PROFESSIONAL SERIES (PRO-Z 500S, 700S, 900S)

Date: February 02, 2021

Models Affected: PRO-Z 500S
PRO-Z 700S
PRO-Z 900S

Subject: Optional Steering Shaft Flange Bushing

FIGURE 1

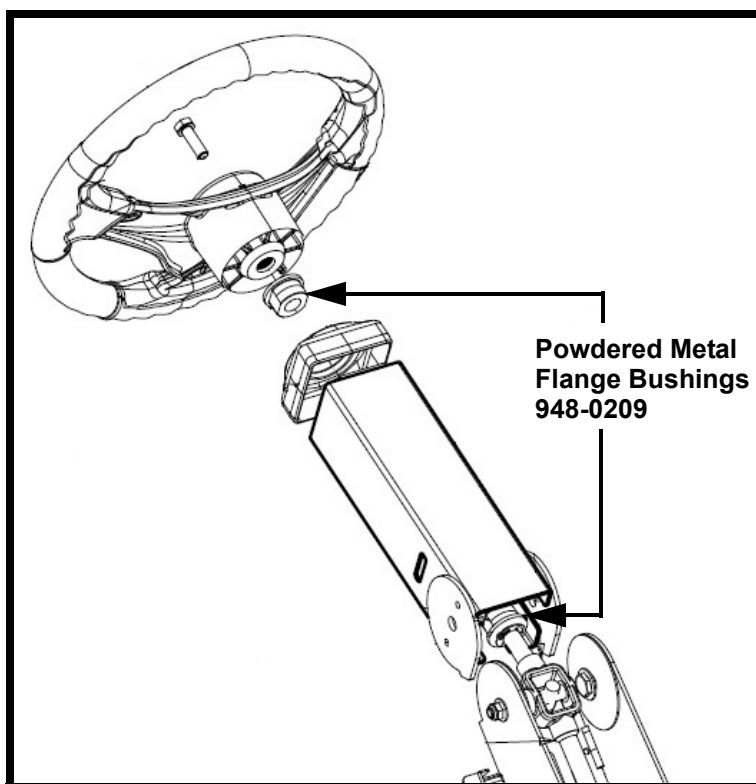
We have received reports of a rattling noise from the steering column. This rattling noise occurs from the two (2) powdered metal flange bushings **948-0209** located in the upper steering column. This is not a mechanical failure and this issue does not occur on every unit manufactured.

If your customer mentions or is annoyed about the rattling noise from the steering column, we now offer an optional flange bushing made of Delrin polymer material. This material is designed to replace metal components. It combines a low-friction and high wear resistance quality.

FIGURE 4

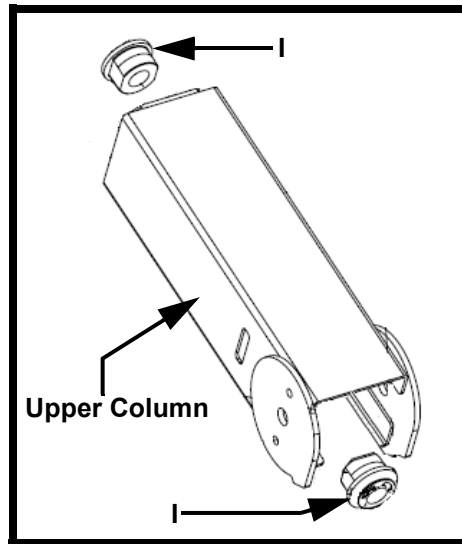
14. Install one (1) of the new **741-07090** Flange Bushings (I) into the upper column with the inner flange pointing upward. The flange bushing will have a slight press fit into the upper column. Use a soft face mallet to seat the flange bushing. Install the remaining **741-07090** Flange Bushing into the lower portion of the upper column using the soft face mallet. See Figure 4.
